MONITORING YEAR 0 ANNUAL REPORT FINAL

HUNTSMAN MITIGATION SITE

DMS Project No. 100123

Subject: Huntsman Draft MYO Report Review
Yadkin River Basin – CU# 03040102
Wilkes County
DMS Project ID No. 100123
Contract # 7891

2018 Aerial Photography

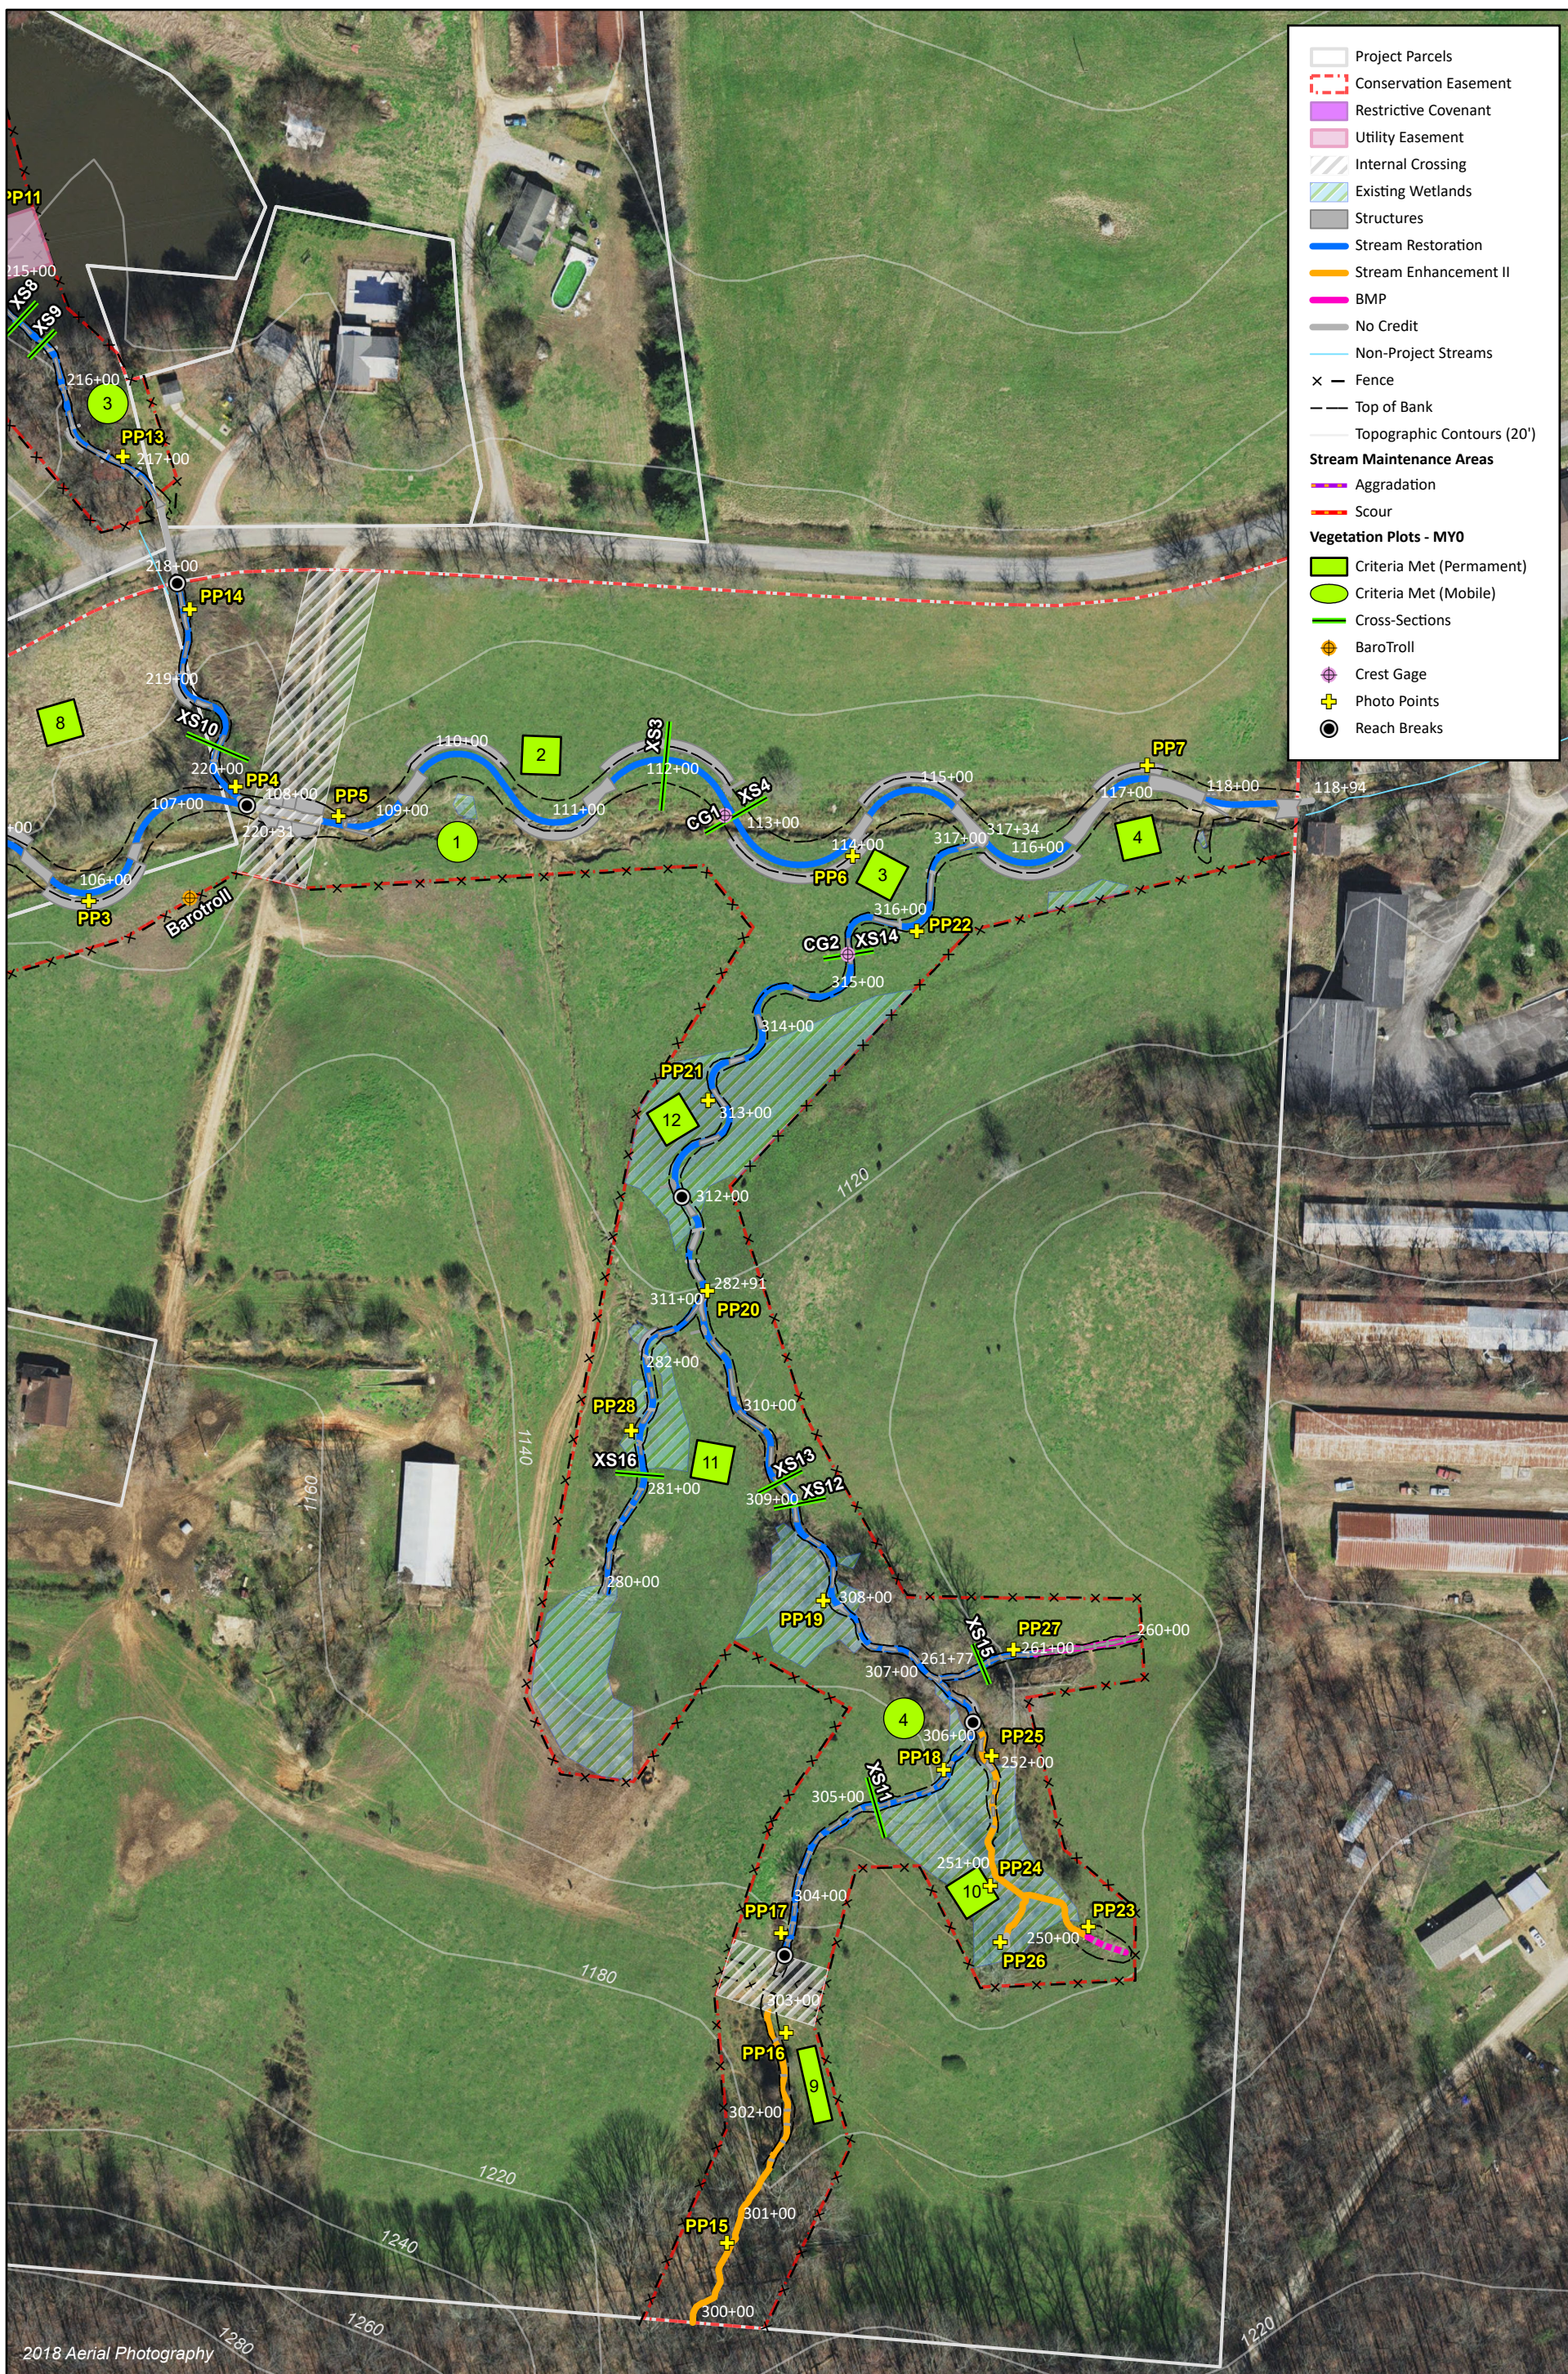
- 3.4 Stream Areas of Concern: Thank you for providing photos of the Stream Areas of Concern in Appendix A. Please add these locations to the CCPV. Are there any maintenance activities planned to correct these issues at this time?

- CCPV: Recommend changing the color/line type of the conservation easement so it is easily discernable from other line work.
- Photo Points for Trapper Trib and Rifle Trib do not seem to indicate a defined channel with bed and bank. These credits are potentially at risk if these tribs are unable to maintain stream features and become wetlands. Please provide an update in MY1 regarding the condition of these two tribs.

7. *CCPV: The Fence Line appears to be within the conservation easement in many areas on the CCPV. The asbuilt survey shows fence locations outside or on the conservation easement line. Please verify the fence was not installed inside the conservation easement and ensure correct line work is shown on CCPV.*

Wildlands Response: Stream areas of concern have been added to the CCPV maps for the final submittal. Depending on contractor availability, maintenance activities for areas of concern will be conducted in either late MY1 or early MY2. Wildlands will provide a status update in the MY1 report.

Wildlands Response: Wildlands verified that the fence line polygon was obtained from the as-built survey file. The issue was with symbol that was used to reflect the placement of the fence. The symbol has been corrected and updated, and it now correctly reflects the alignment of the fence.

Wildlands Response: The conservation easement color was changed to red so that it is easier to see in the CCPV figures.
